Claims 43-46 are currently pending and presented for reconsideration. In view of the above amendments and following remarks, reconsideration and withdrawal of all grounds of objection and rejection are respectfully requested.

MARKED UP VERSION SHOWING AMENDMENTS

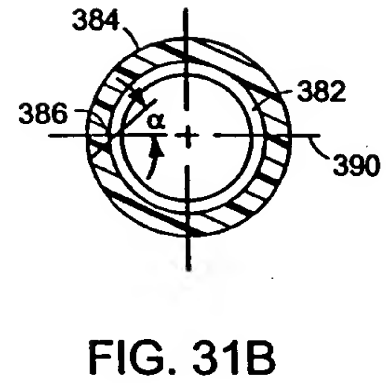
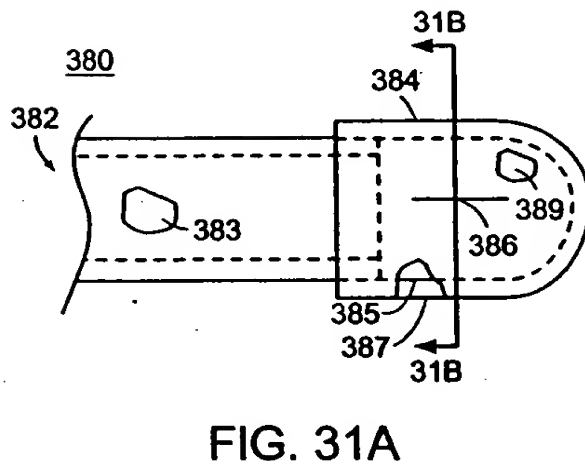
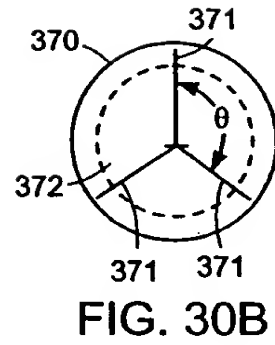
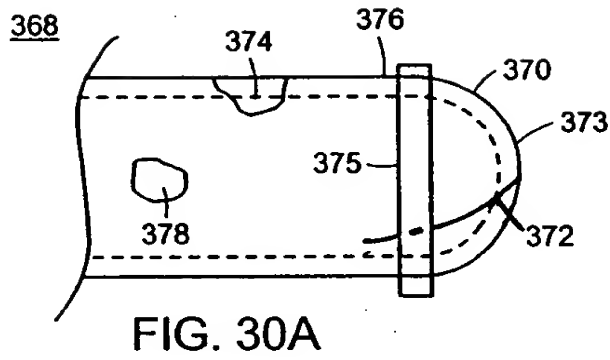
FIG. 30A was objected to because it appeared as though the slit cuts through the collar and the angle of the slit does not correlate with the angle of the slit in FIG. 30B. FIG. 30A is hereby amended. Approval of the proposed change is respectfully requested.

Approved for
3/24/03
